*Our reference: DBC 0047 Amendment C91moor Submission*

**AMENDMENT C91 TO THE MOORABOOL PLANNING SCHEME**  
**Application of the Land Subject to Inundation Overlay**  
**Submission**

## **Re: Bacchus Marsh Planning Scheme Amendment C91**

Figure 1 Proposed LSIO

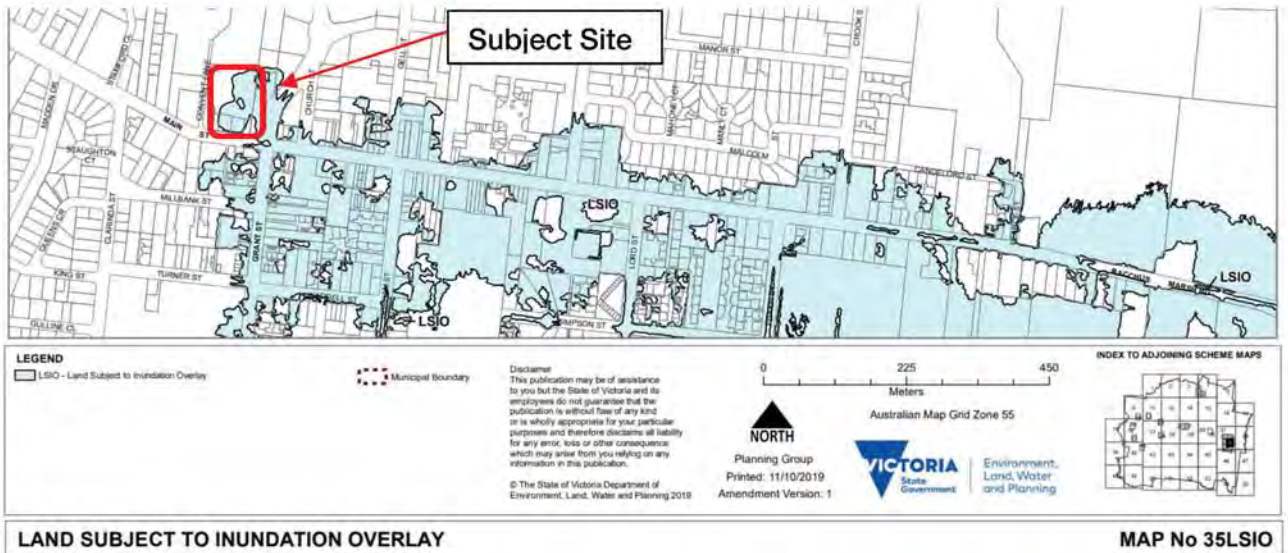
This analysis is primarily concerned with the site formally known as 94-98 Main Street Bacchus Marsh, cornering Main and Gisborne Roads. The proposed LSIO for the area is shown in Figure 1 with the subject site highlighted. The site is approximately 7,000m<sup>2</sup> and it is noted that this is on the area is on the edge of the proposed LSIO and as will be shown in this report on the edge of the model extent. The site and surrounds are shown in Figure 2.

These model points are generally acceptable for a large scale model with a focus on riverine and large drain flows. However, this site in particular is much more nuanced urban flood study site, and in trying to meet the requirements of the larger study has been overlooked in a number of ways.

Figure 8 Flow Input area C1p3 surrounding subject site

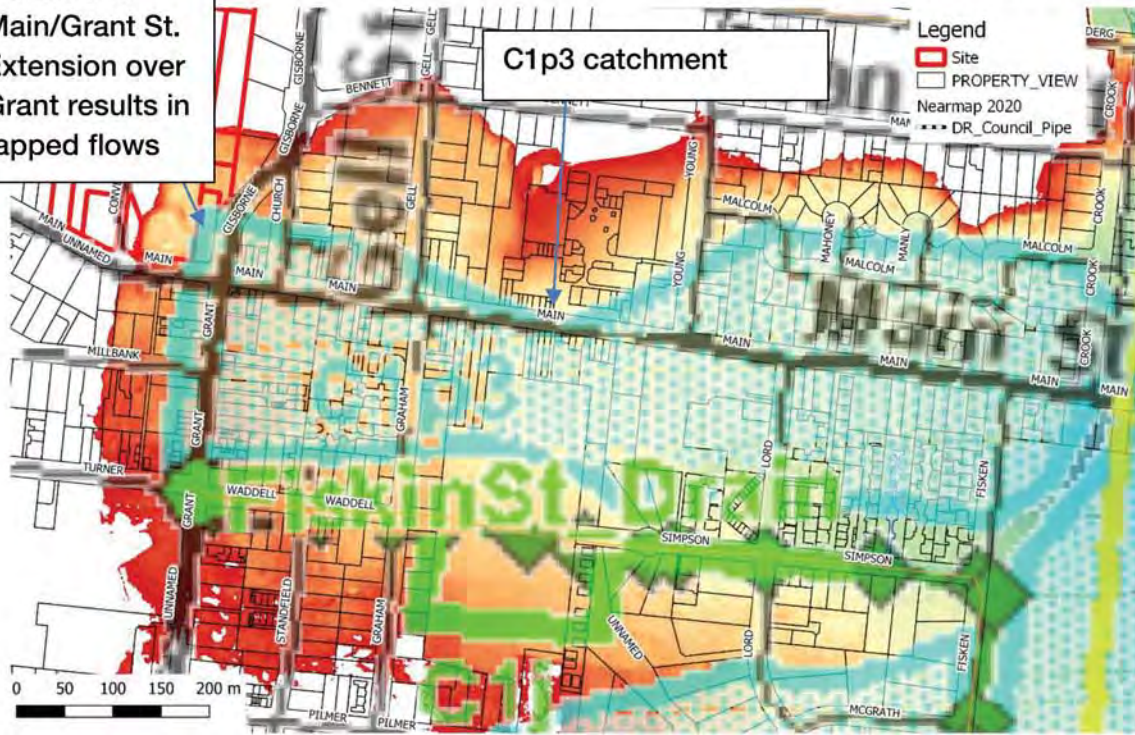
The input method influences this site in a number of ways. The flows that are seen on the site are probably from the direct grid application (the catchment application erroneously just covers into this site), that decision along with the grid resolution and lack of council pipes traps and directly fills the site as a bathtub. As there is no outlet, the flooding gets deeper and larger on the site as the ARI is increased. This is seen in the mapping with all ARI's represented (Figure 10). The other possible flooding of the site from this model technique is excess flow from the pit spew method travelling north up Grant Street and falling off the edge of the model into the site. This method is less likely but possible, and here the grid resolution issues and lack of definition around the roundabout at Grant and Main streets becomes a much bigger driver of the flooding. This was confirmed on site and can be seen in Figure 4. Flow is much more likely to turn right at Main Street (due to the influence of the roundabout and local levels) with any minor spill accounted for by the Council pipe system.

Should be trimmed to Main/Grant St. Extension over Grant results in tapped flows

- Remove the proposed LSIO on the subject site
- Trim the flood extents to Grant Street/Gisborne Road on the north side of Main Street

Figure 9 Terrain surrounding subject site

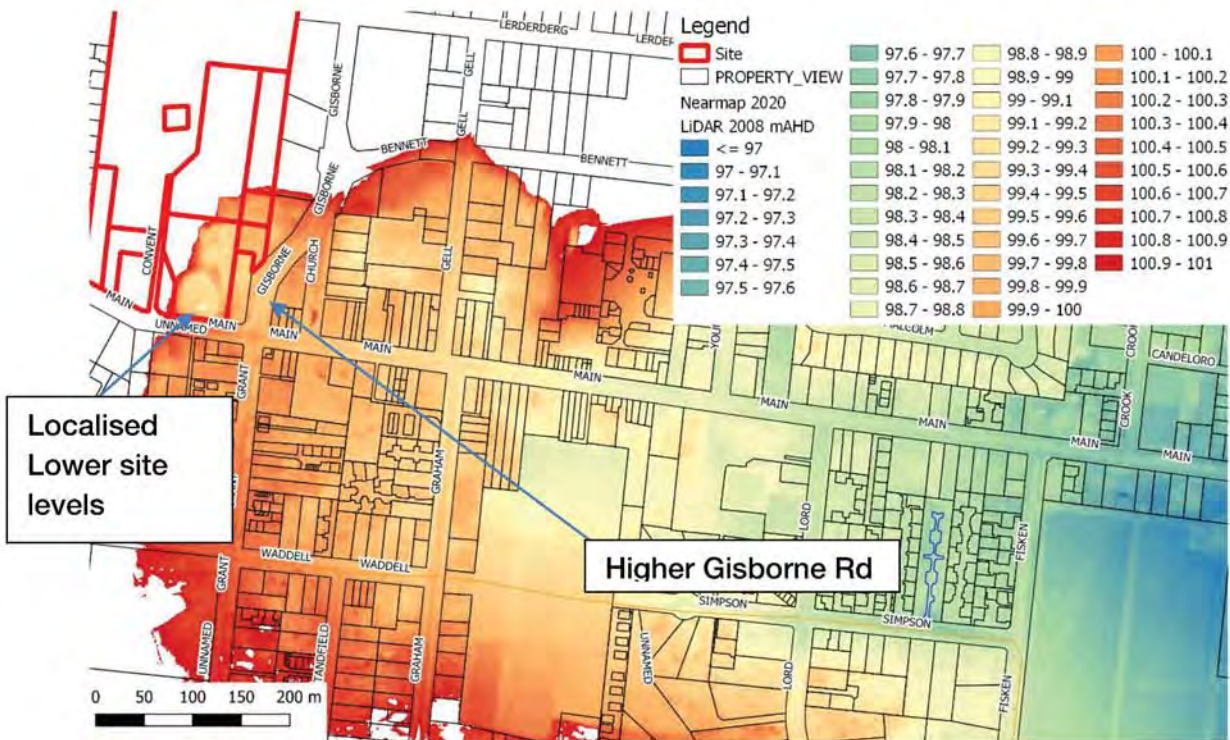
**Council Pipes** – Again in a large catchment flood study Council pipes have a minor influence in large riverine flows. In this case, and exacerbated by the grid resolution the sites trapped low point fills with water that cannot leave the site. This is one of the reasons that the mapping shows flood extents in all ARI's (Figure 10). The site is well serviced by Council pipes (Figure 3) with a number in particular designed to drain the low point. Not having these pipes in this model impacts this site and this part of the model more than the rest of the model.

Figure 1: Subject site and the proposed SBO (Source: [www.mapshare.vic.gov.au/vicplan](http://www.mapshare.vic.gov.au/vicplan))

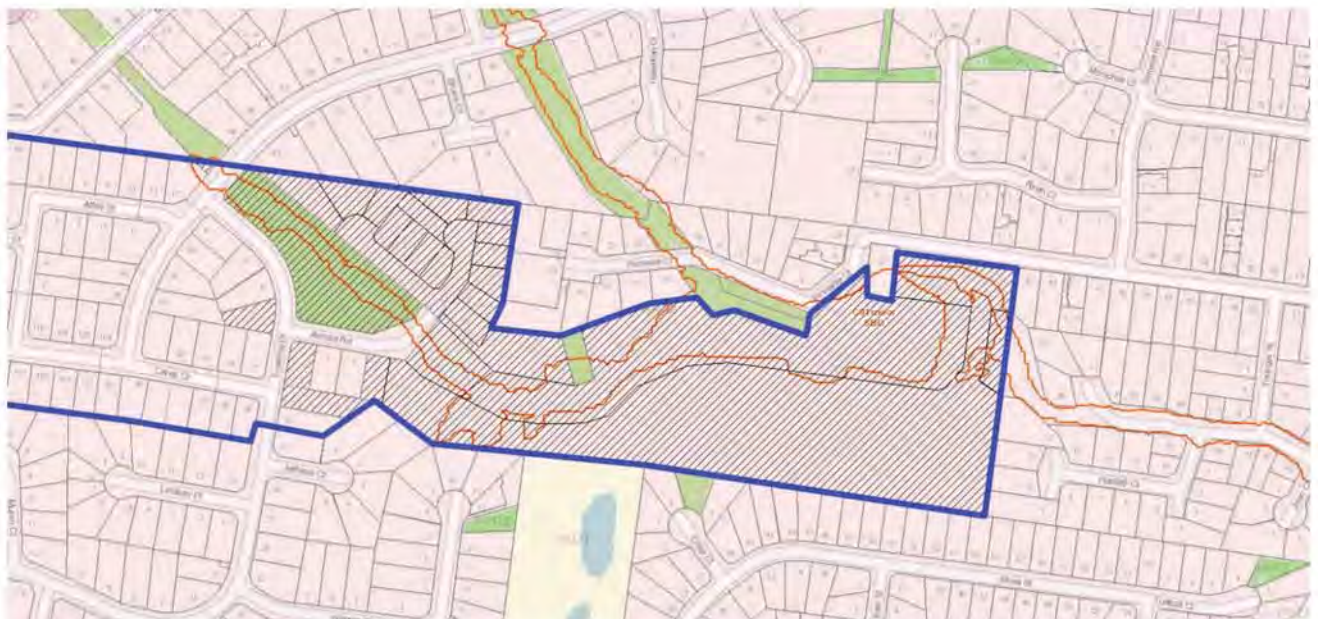
Maps 34 and 35 as exhibited in C91 map the subject land as partly included within the Special Building Overlay (SBO). A representation of the proposed SBO is below:

A copy of the plan currently being assessed by Council is attached, as are the approved plans for the works to construct a retarding basin (as approved by Melbourne Water and Council). Whilst the retarding basin is not yet constructed, it is expected that construction will occur within the next 12 months. These works will ensure that properties alongside the waterway are protected from any potential impacts of future flooding. As such, once constructed, the proposed SBO will become superfluous.

We submit that given the approved waterway works are due for construction in the near future, and are likely to be completed prior to the gazettal of this planning scheme amendment, that the SBO should be reassessed to align with the plans for the retarding basin construction. We would be happy to work further with Melbourne Water and Council to supply information that would assist this process if required. We have enclosed with this submission:
